State of New Jersey  
DEPARTMENT OF ENVIRONMENTAL PROTECTION  
DIVISION OF ENVIRONMENTAL QUALITY  
CN 415  
Trenton, N.J. 08625-0415  
(609) 987-6402  
Fax (609) 987-6390

September 20, 1991

Thank you for your letter dated June 6, 1991. We have reviewed the NRC's rationale for not licensing various areas and materials on the Heritage Minerals, Inc. (HMI) property and other historical information including material provided by Jack Lord, Vice President of HMI, on materials processing at the site.

ATTACHMENT 1

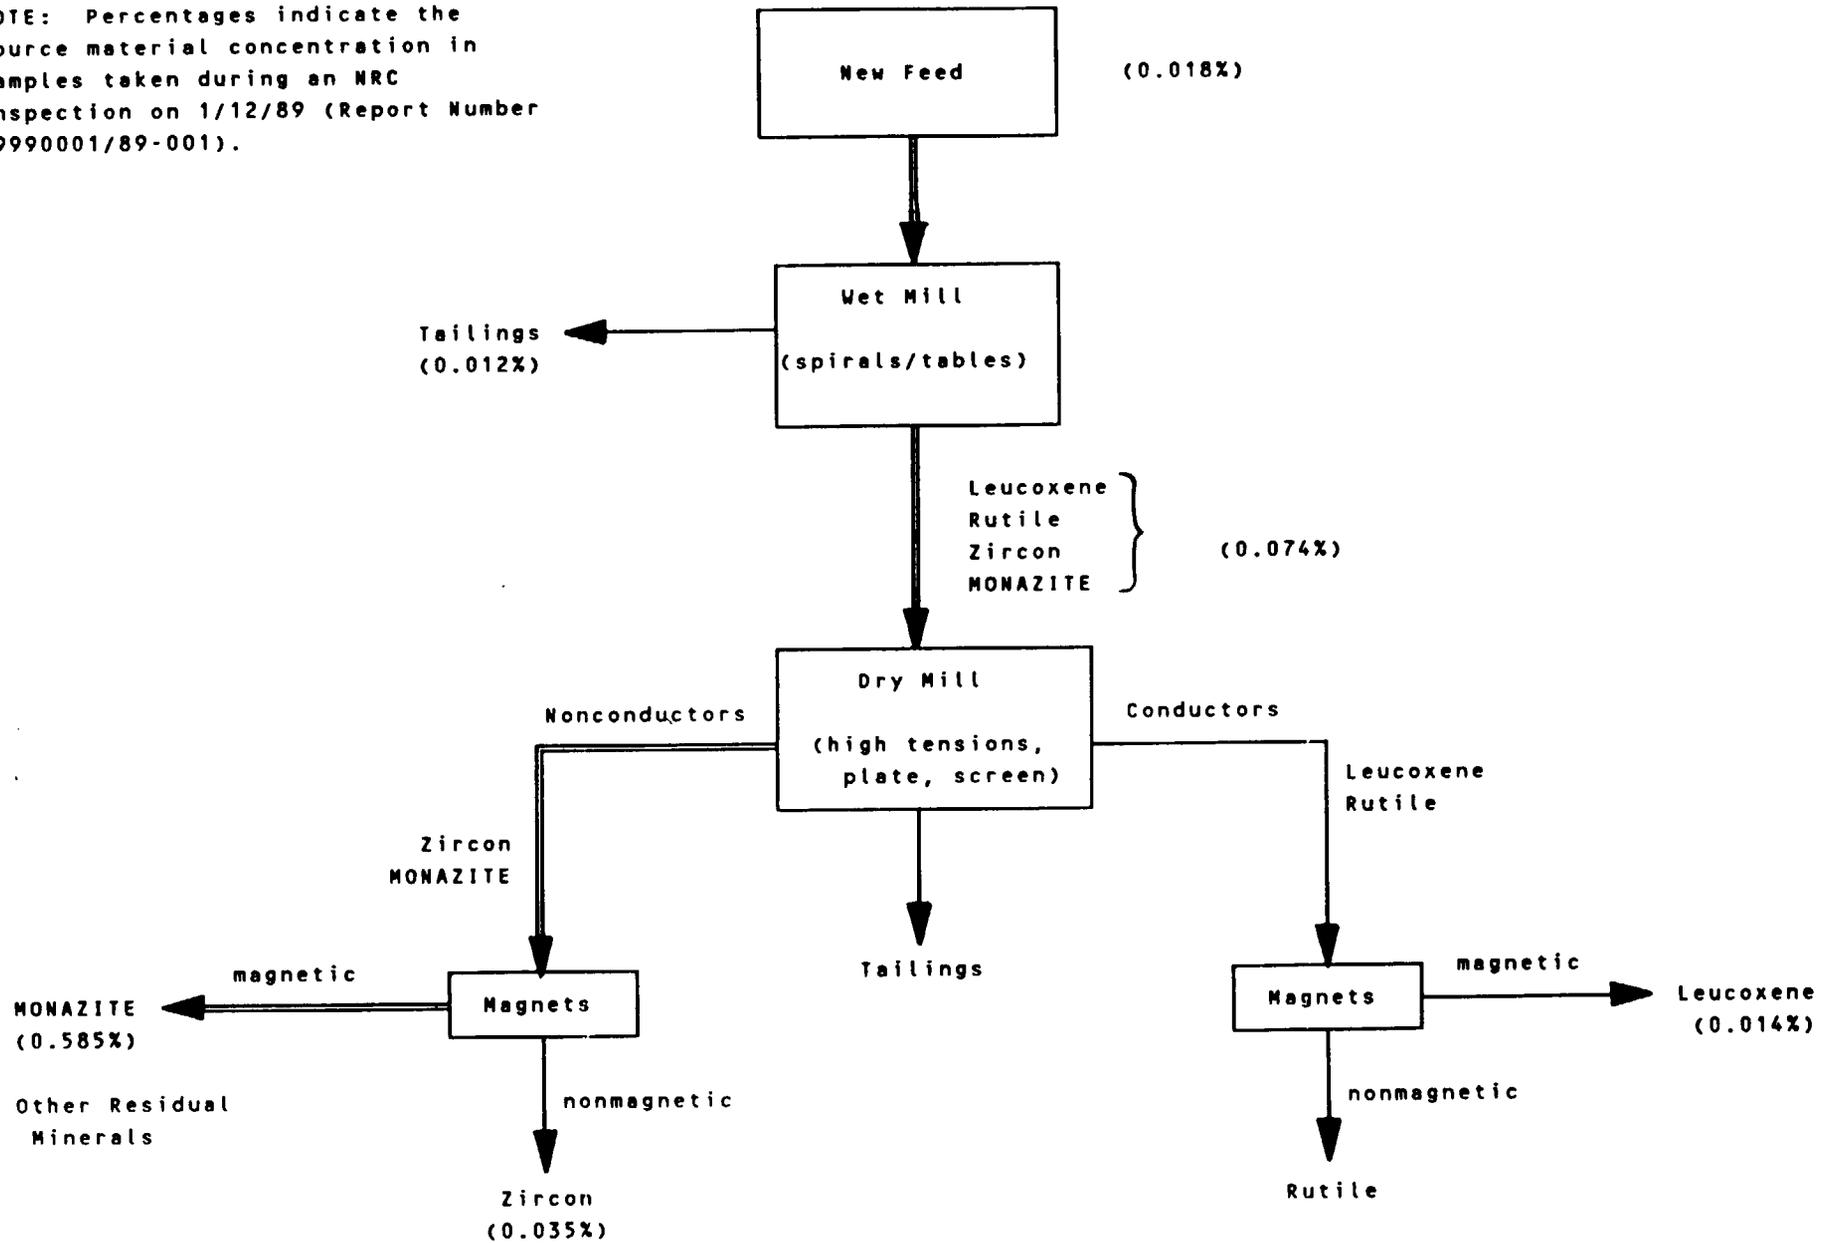
wet mill where zircon, leucoxene, rutile, and monazite were concentrated (see Attachment 1). In the dry mill, the conductors (leucoxene and rutile) were separated from the non-conductors (zircon and monazite). The rationale which you provided to us only addresses the process stream for conductors, which does not contain monazite. We address below the process stream for non-conductors in which monazite is separated from zircon.

During MRI and HMI Phase I operations (November 1986 - March 1990) at the point where zircon was magnetically separated from monazite in the dry mill, the monazite waste stream, at licensable source material concentration, was sent to a hopper where it was combined with tailings from the wet mill. These combined tailings were then pumped to the combined tailings pile. Perkins and Cole, attorneys retained by HMI, in their September 27, 1990 letter to you stated that "... monazite waste at source material concentrations was re-combined with other materials and placed in the area marked in blue on the site map [the combined tailings pile]..." HMI did not possess an NRC license for any portion of Phase I operations. As documented in NRC Inspection Report Number 99990001/89-001, HMI "possessed and used ... monazite waste in which the concentrations of source material were greater than 0.05% by weight without being authorized to do so by an NRC license..."

It is clear that, during MRI and HMI Phase I operations, radioactively clean wet mill tailings were contaminated by a monazite waste stream exceeding the threshold for classification as source material before being stockpiled on the combined tailings pile. Furthermore, during Phase II operations, HMI stockpiled a "monazite-rich product" in an unregulated pile. During both phases of operation HMI concentrated monazite, containing licensable amounts of uranium and thorium, without an NRC license.
